VSH PREMIER CIRCLE ARB 2022-29

SUBMISSION OF FINAL SITE PLAN

June 21, 2022

PROJECT NARRATIVE

TIMMONS GROUP
 TJACH PREMIER CIRCLE
 ALBEMARLE COUNTY, VA
 PHASE 1 SITE LIGHTING AND PHOTOMETRIC PLAN

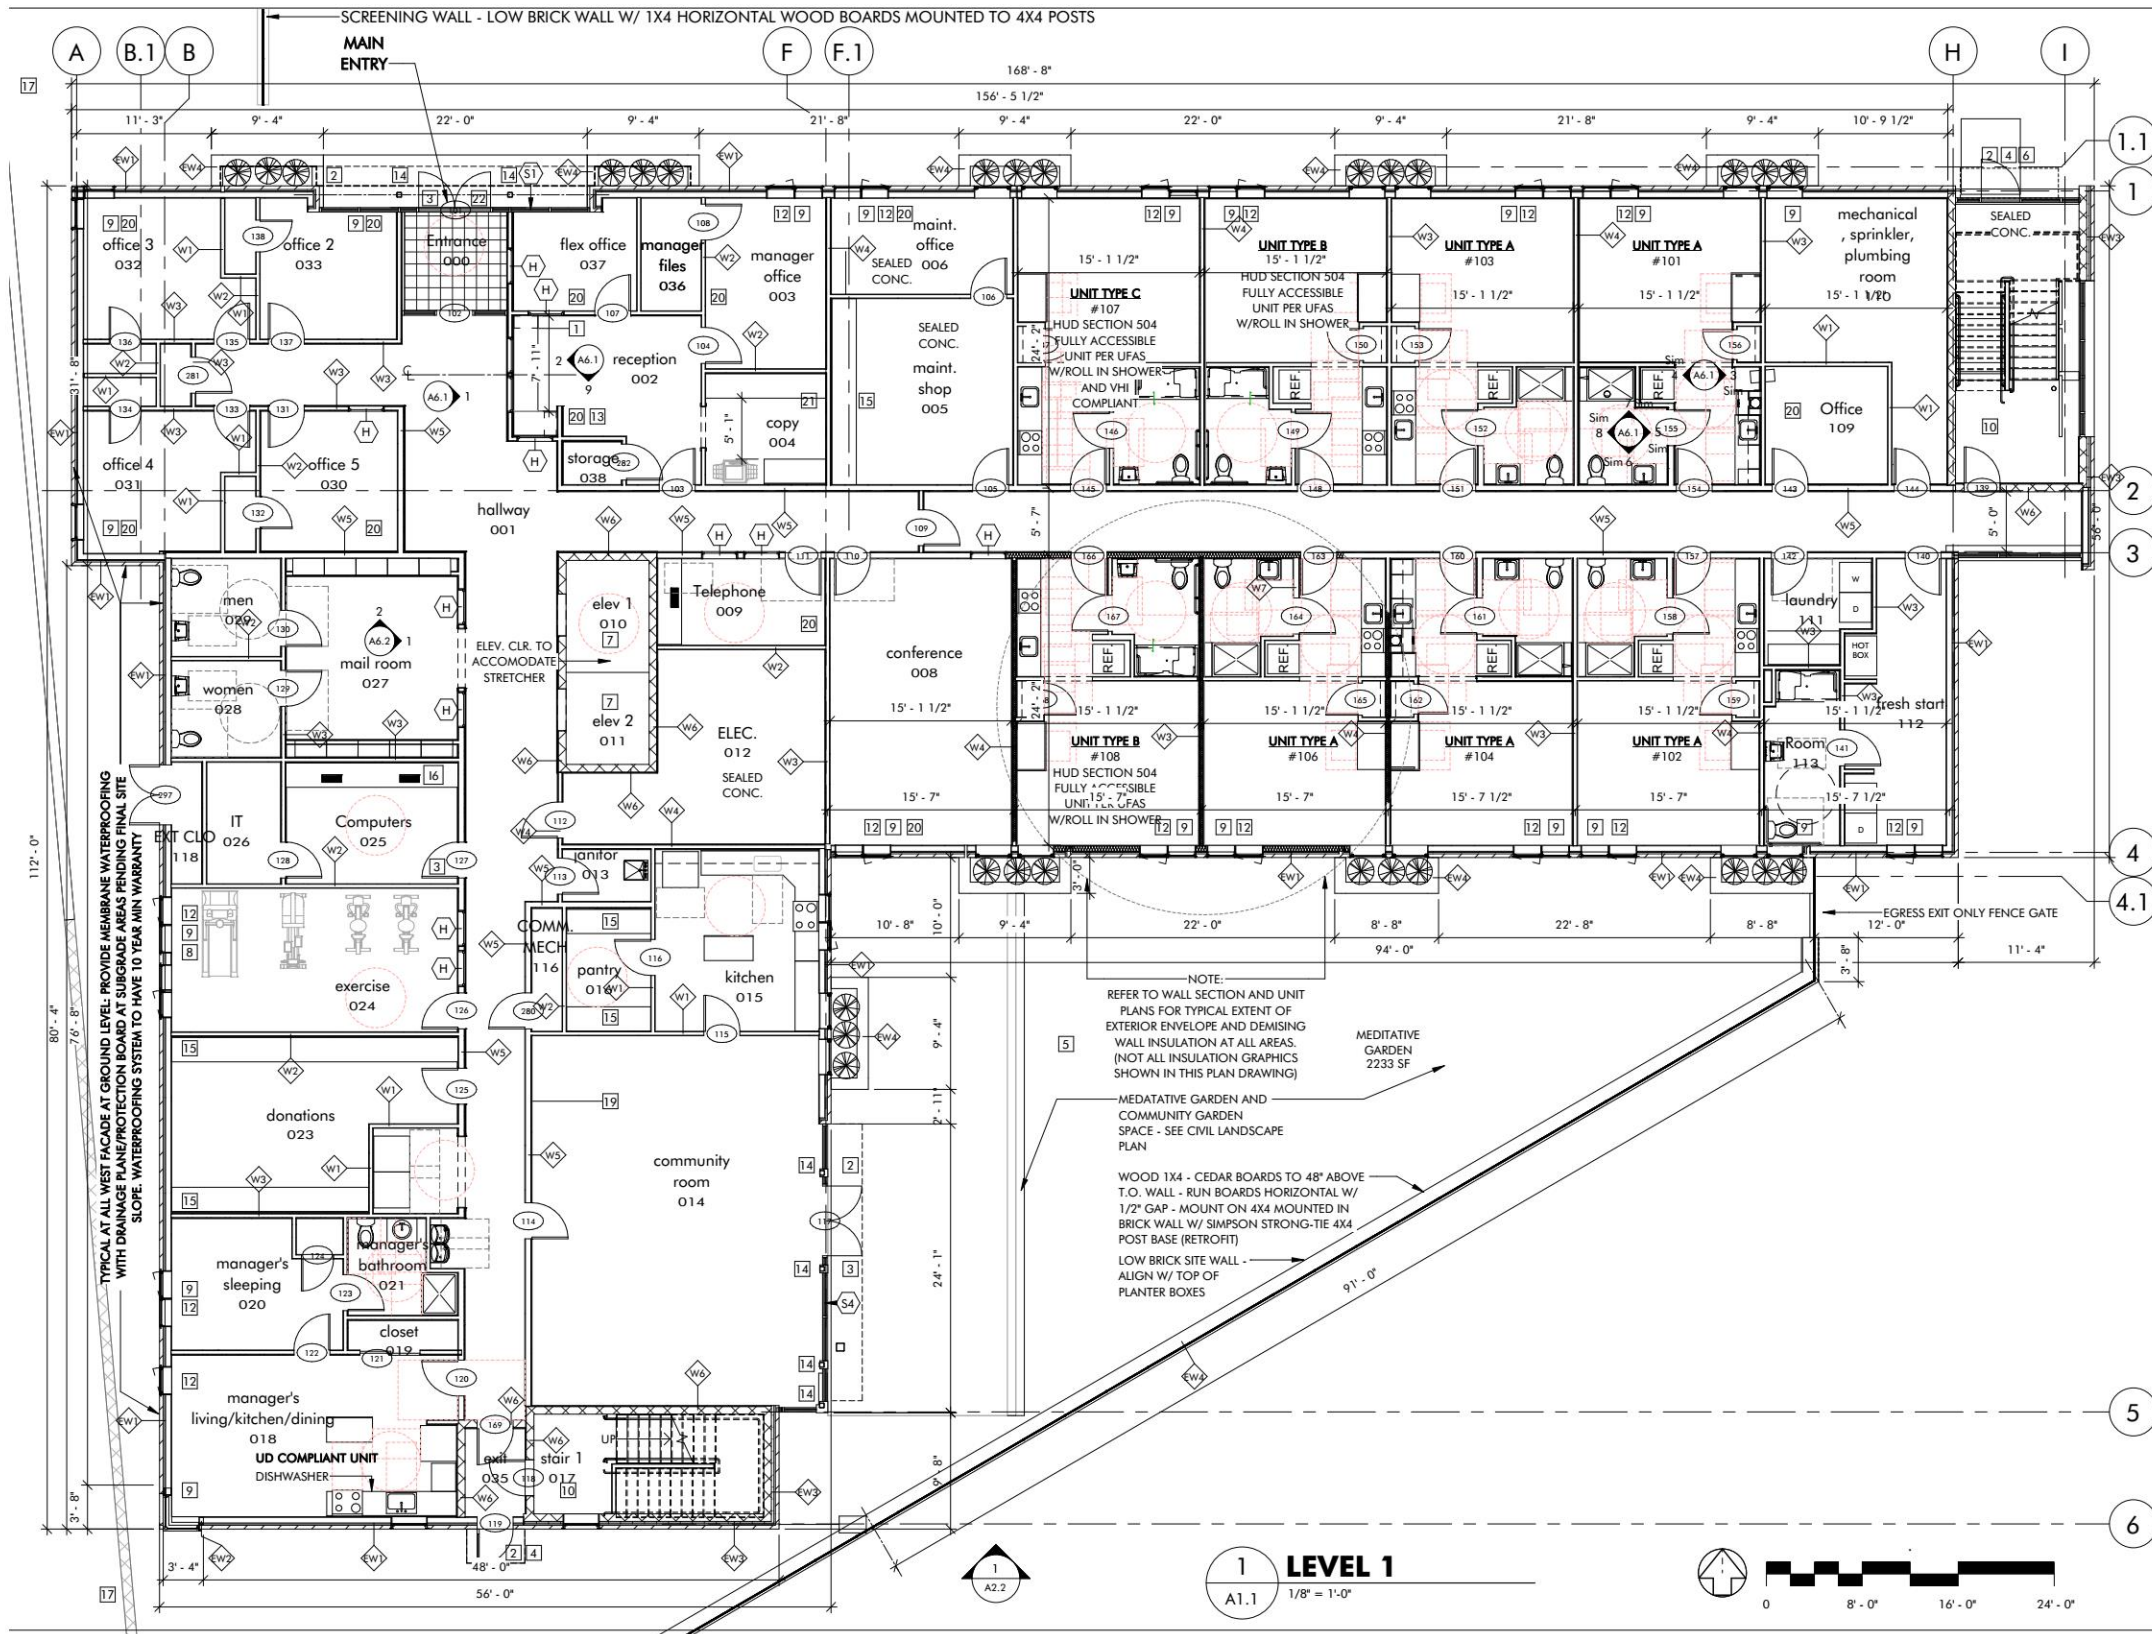
- 10. Revise the lighting plan to indicate that the plan was calculated using an LLF of 1.0 for all fixtures and revise the photometrics accordingly.
 Lighting plan revised. See Final Site Plan.

- 11. Revise the plan to indicate the fixture heights will not exceed 20' including the base
 Lighting plan revised. Fixture height does not exceed 20' including the base. See Final Site Plan.

- 12. Revise the lighting plan to include fixture locations and illumination values for the wall-mounted lights.
 Lighting plan revised. See L3.1 in the Final Site Plan for fixture locations. See Final Site Plan.

- 13. Add the standard lighting note to the plan "Each outdoor luminaire equipped with a lamp that emits 3,000 or more initial lumens shall be a full cutoff luminaire and shall be arranged or shielded to reflect light away from adjoining residential districts and away from adjacent roads. The spillover of lighting from luminaires onto public roads and property in residential or rural areas zoning districts shall not exceed one half footcandle."
 Lighting plan revised. Note has been added to sheet L3.1 in the Final Site Plan. See Final Site Plan.

item 8: ELEVATOR TOWER VISIBILITY AND MATERIAL

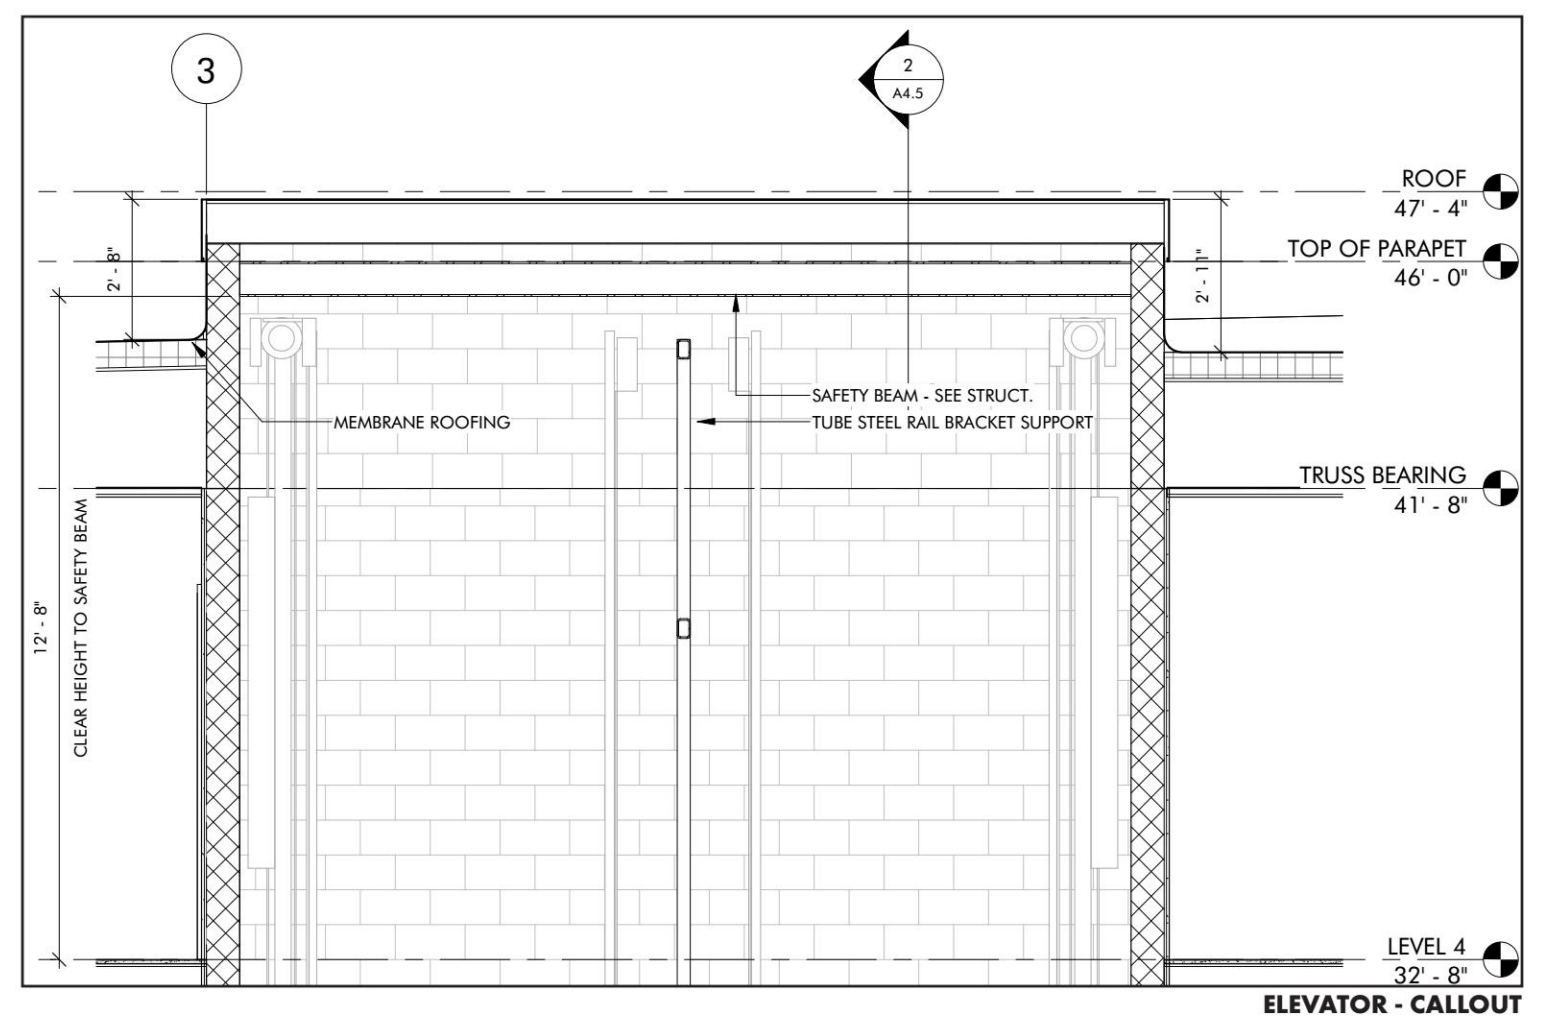
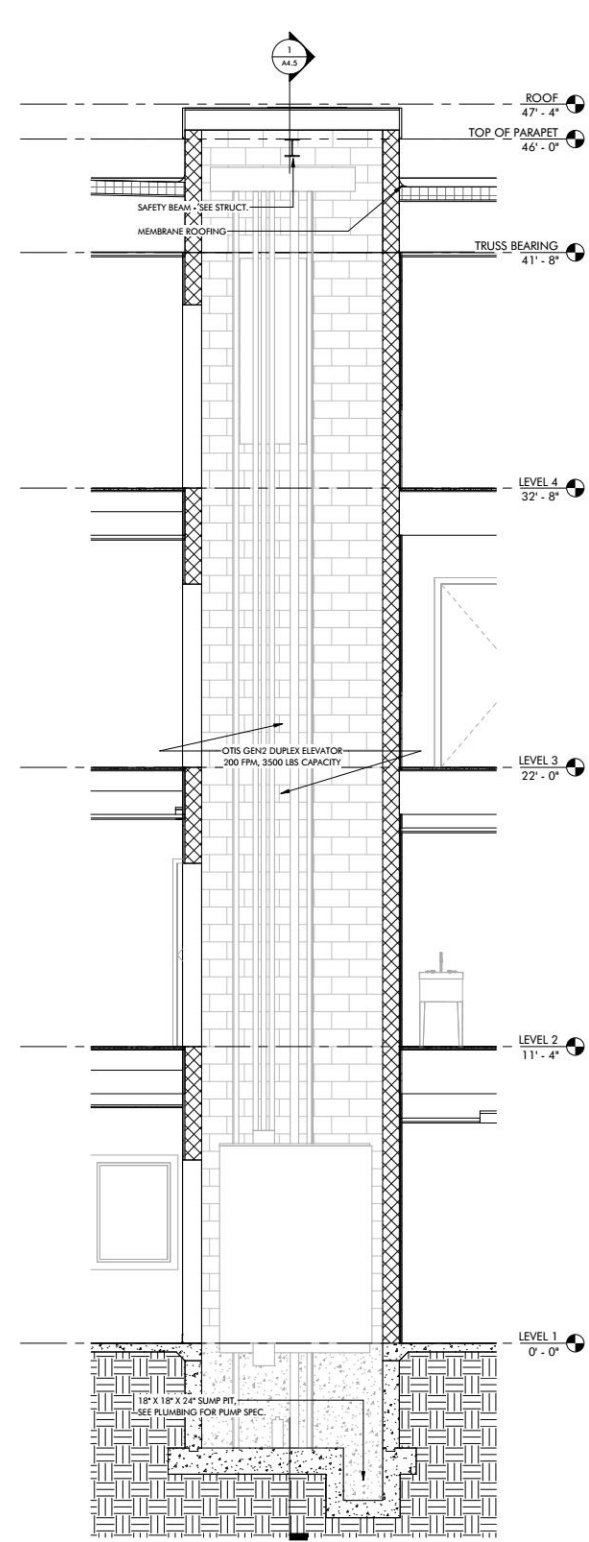
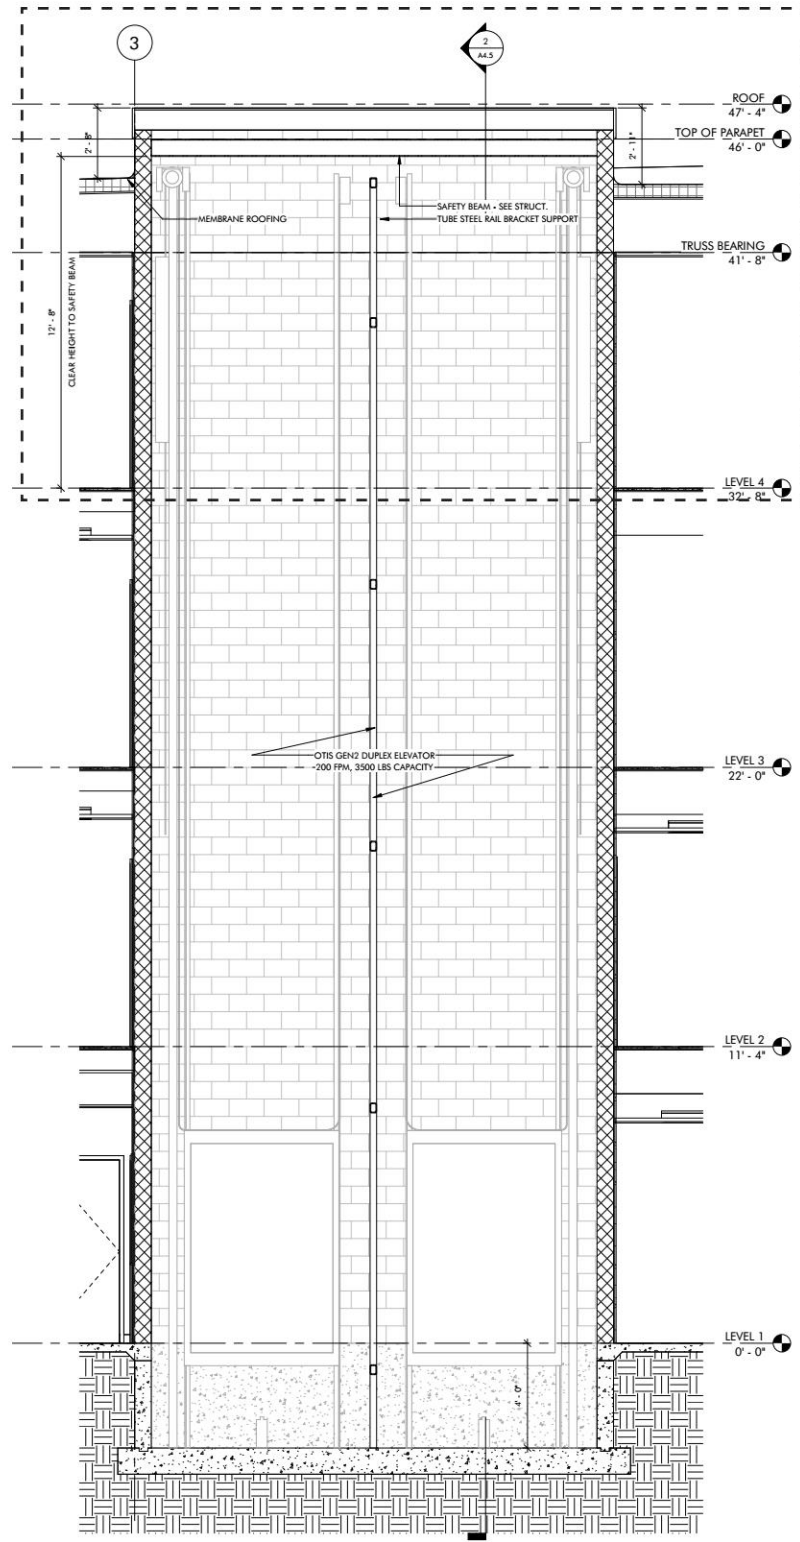
7. Confirm that the visibility of roof-mounted mechanical equipment has been considered in the perspective drawings.

8. Revise the architectural drawings to show the finish (material, color, detailing) of the elevator tower and show the tower in the perspective drawings.

9. Add the standard mechanical equipment note to the architectural plans: "Visibility of all mechanical equipment from the Entrance Corridor shall be eliminated."

In the renders to the right, the mechanical equipment and elevator tower do not appear until the view is taken from 21' above the ground and higher. See page 13 for more details regarding the roof plan.

In the renders to the right, the elevator tower is rendered in the proposed finish and detailing - it will match the roofing material, a membrane roof that will not be visible from the E.C. See page 12 and 13 for more details.

See note below. See page 13 for more details regarding the roof plan.

ROOF PLAN

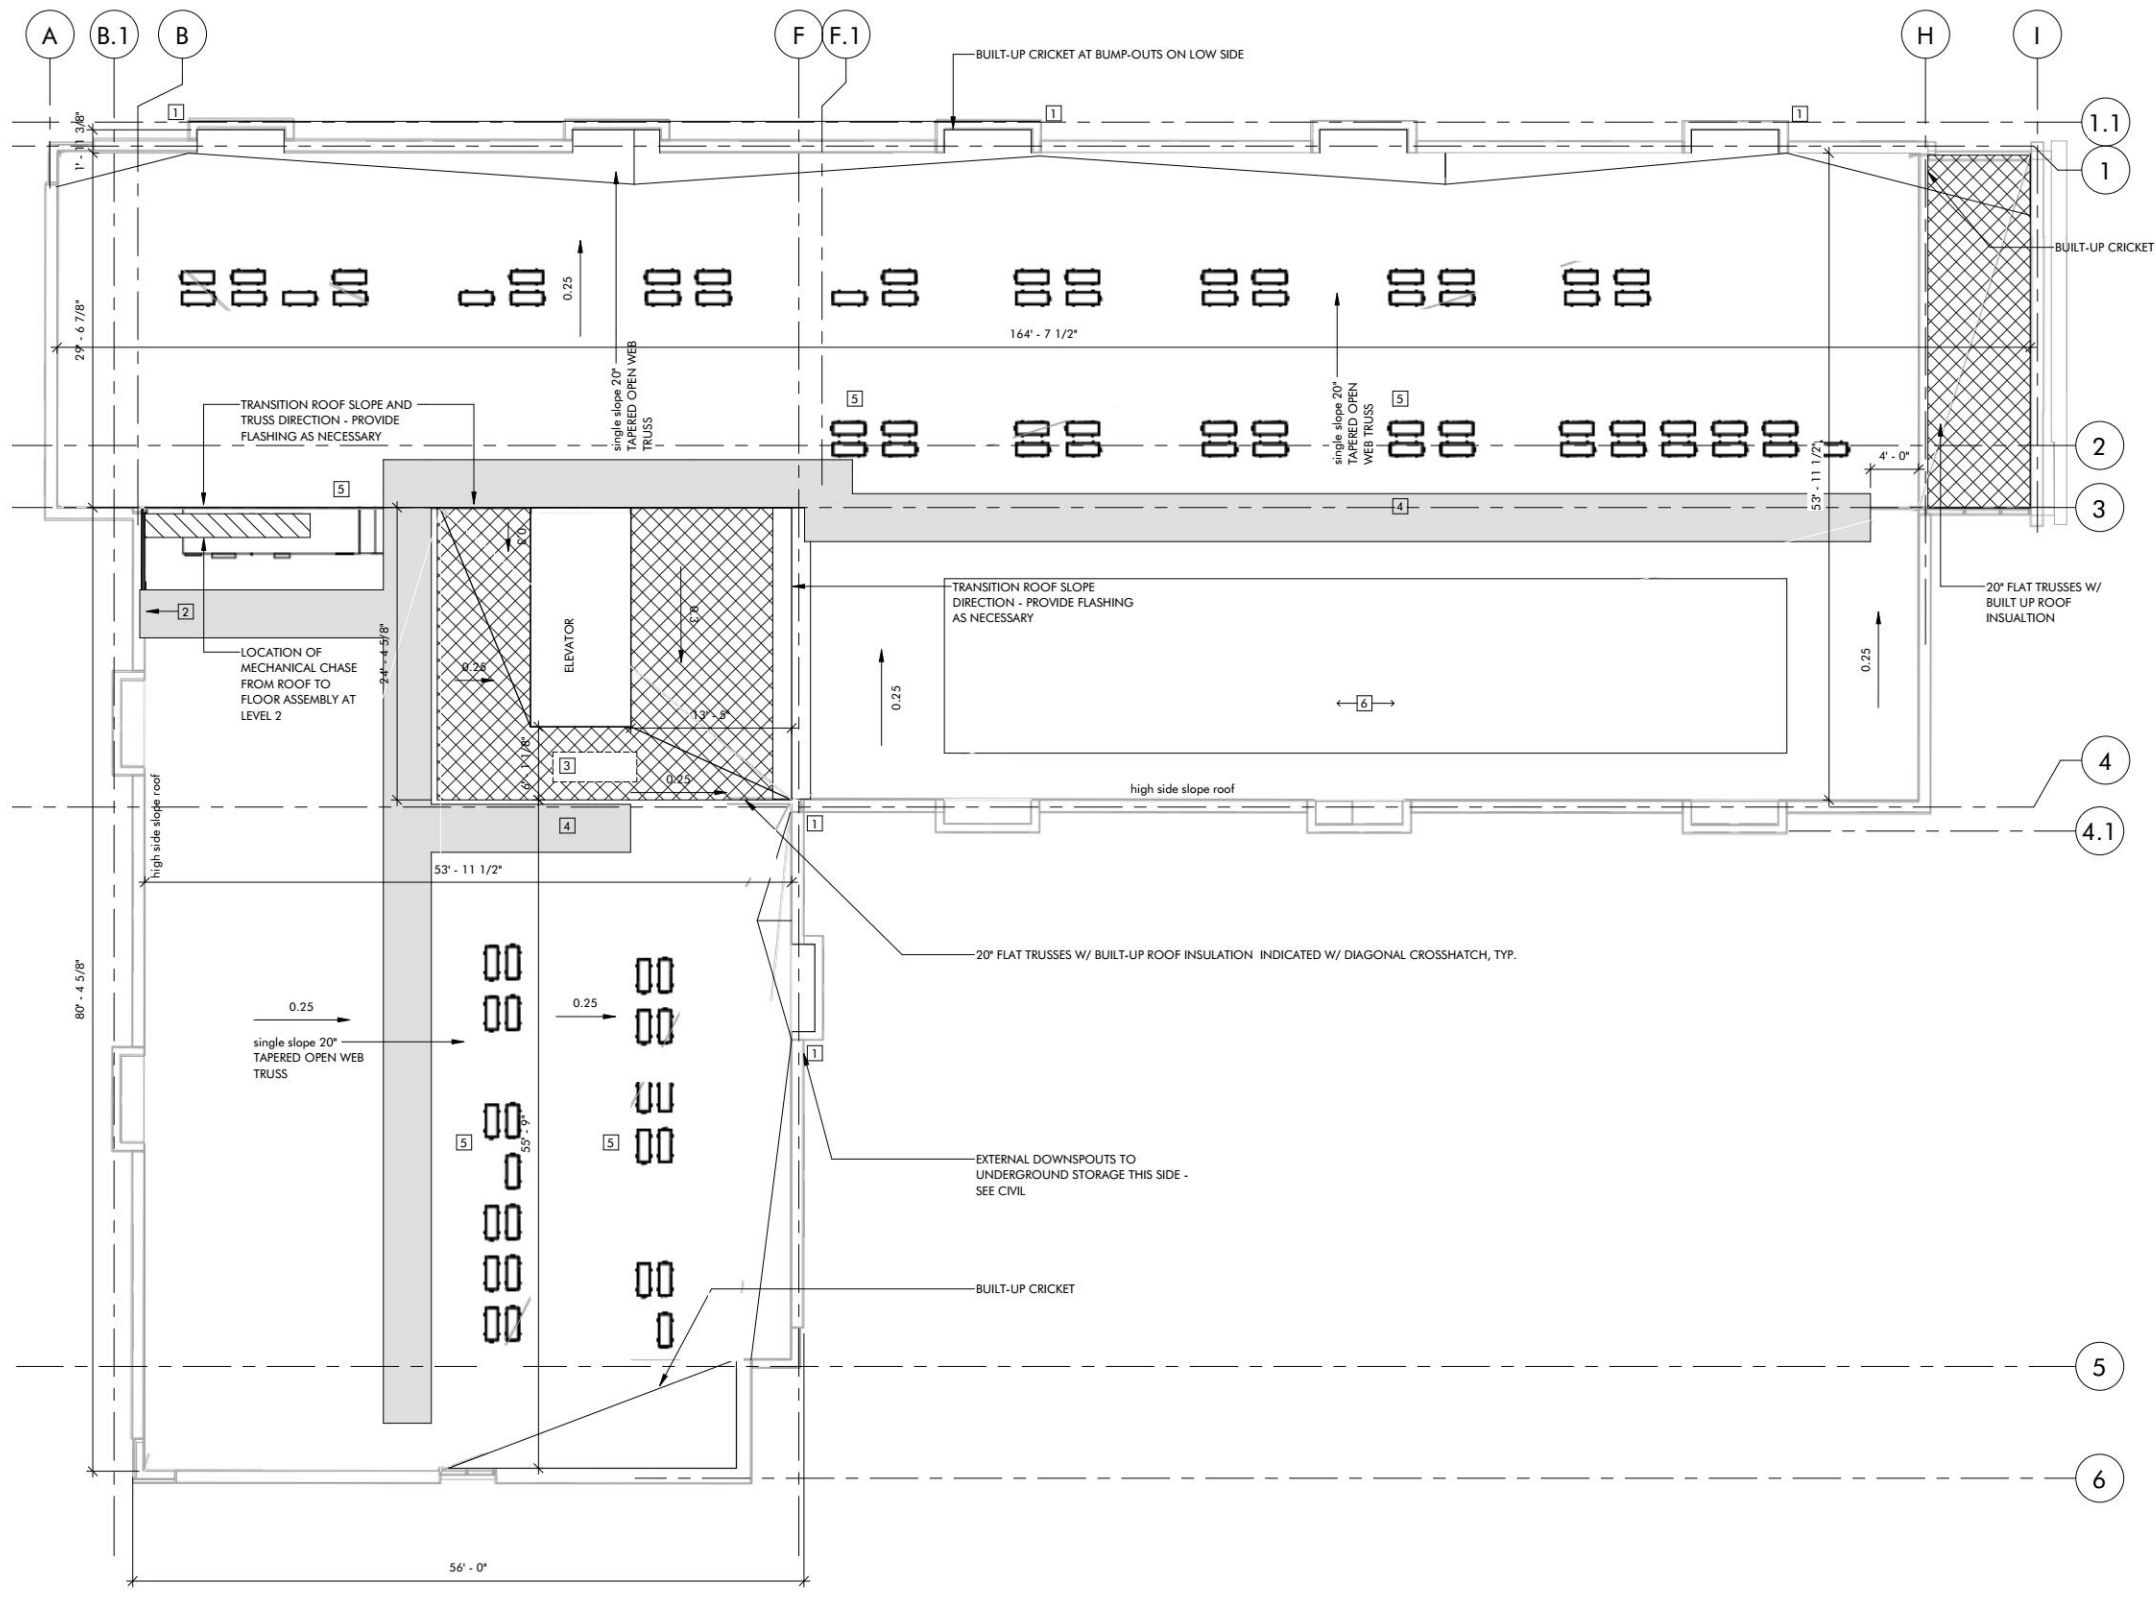
9. Add the standard mechanical equipment note to the architectural plans: "Visibility of all mechanical equipment from the Entrance Corridor shall be eliminated."

- 1 DOWNSPOUT LOCATION - SEE CIVIL
- 2 RAILING @ D.O.A.S. ROOF UNIT - SEE MECH
- 3 ROOF ACCESS HACH - 30"X84" MIN
- 4 WALK PAD
- 5 ROOF TOP MECH UNITS - SEE MECH.
- 6 PROPOSED AREA FOR FUTURE PV APPLYS
- 7 VISIBILITY OF ALL MECHANICAL EQUIPMENT FROM THE ENTRANCE CORRIDOR SHALL BE ELIMINATED
